# Access Compliance Report

## Public Rights-of-Way

Intersection ID: 12711	Main Street: S_TRYON_ST	Cross Street: W_STONEWALL_ST	Location: N
ADA ID: 0A7399014689	Ramp Type: Perp	Initial Pass/Fail: Fail	Overall Compliance: No
Severity Score: 26.25			
Codes/Mitigation Info/Possible Solution		Field Measurements/Component Compliance

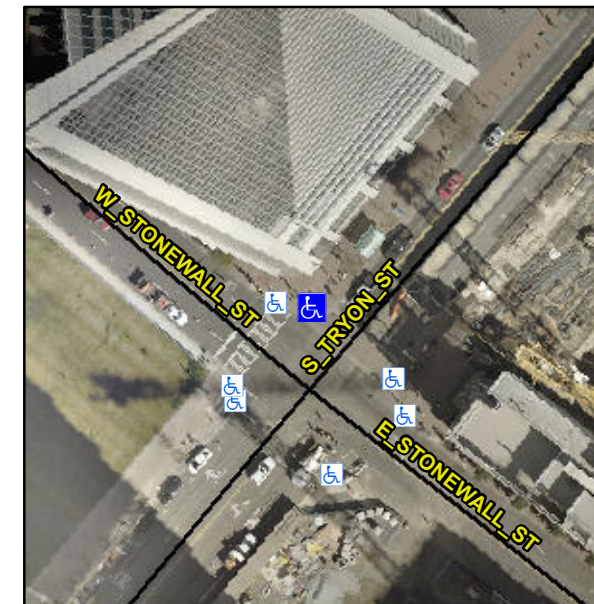
**R304.2.2, R304.5.3**

Compliance	Description	Data	Compliance	Description	Data
N/A	Ramp Length (in)	70.0	No	Ramp Slope (%)	13.8
Yes	Ramp Width (in)	55.0	No	Ramp XSlope (%)	2.4
N/A	Flare Type LT	N/A	N/A	Flare Type RT	N/A
N/A	Flare Slope LT (%)	N/A	N/A	Flare Slope RT (%)	N/A
N/A	Flare Traversable LT?	N/A	N/A	Flare Traversable RT?	N/A
N/A	Landing Length (in)	N/A	N/A	DWS Provided?	N/A
N/A	Landing Width (in)	N/A	N/A	DWS Contrast?	N/A
N/A	Landing Slope (%)	N/A	N/A	DWS Length (in)	N/A
N/A	Landing X Slope (%)	N/A	N/A	DWS Full Width?	N/A
N/A	Landing Curb? (Y/N)	N/A	N/A	DWS Offset (in)	N/A
N/A	Shared Landing?	N/A			
N/A	Gutter Ponding?	N/A	N/A	Gutter Slope (%)	N/A
N/A	Gutter Lip Ht (in)	N/A	N/A	Gutter X Slope (%)	N/A
N/A	Painted X Walk1?	Yes	N/A	Painted X Walk2?	N/A
	X Walk 1 Direction	To SE		X Walk 2 Direction	N/A
N/A	X Walk 1 Width (in)	144.0	N/A	X Walk 2 Width (in)	N/A
	X Walk 1 Slope (%)	0.1		X Walk 2 Slope (%)	N/A
	X Walk 1 X Slope (%)	1.3		X Walk 2 X Slope (%)	N/A

**Remove & Replace Entire Ramp.**
